Warning Time for Maximum Precipitation Events

Rev 4, 10-30-14

Figure 1. Consequential Flooding Illustration

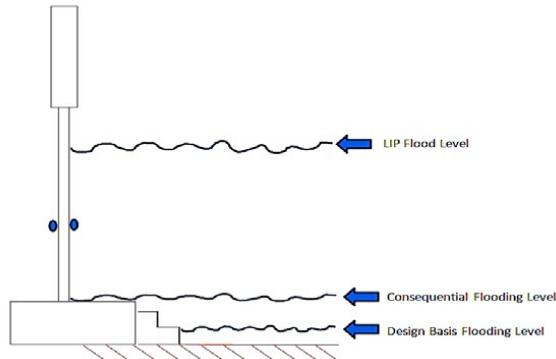
Comment [S17]: The definition addresses consequential flooding but does not "link" it to the term "consequential rainfall" (i.e., rainfall amount capable of leading to consequential flooding), which is used throughout the document.

Comment [S18]: It is not clear what is meant by "current flooding barriers." The staff currently interprets this sentence to mean that consequential flooding is flooding that results in water levels above the permanently-installed flood barriers that prevent damage to SSCs important to safety. If so, it is important to differentiate between permanently-installed flood barriers that are passive vs. those that require actions by plant personnel (e.g., sills vs. flood gates) when defining the threshold for "consequential flooding." For example, is the following true?

"Consequential flooding is ... flooding rises above installed flooding barriers that are permanently in place and do not require any action by plant personnel (e.g., walls, door sills, flood gates, etc.)"

In addition, it appears this definition includes a spurious "not." Is it intended that consequential flooding be defined as a point in which SSCs important to safety are **not** impacted, as suggested by this sentence?

Figure 2. Alternate Action Trigger Flowchart

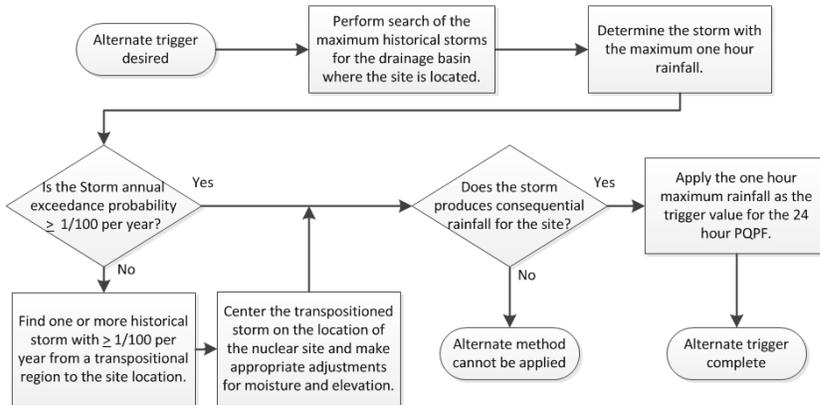
Comment [S23]: The use of the Alternate Action Trigger removes conservatism and could result in trigger levels approaching the consequential rainfall level. Therefore, staff does not currently support this definition of an alternative action trigger. If the number of “false positives” is expected to be too high, licensees can propose alternative triggers on a plant-specific basis for staff review.

Staff also notes a sign error for AEPs in both the text and figure (e.g., AEP = 1/200 vs. recurrence interval = 200 years).
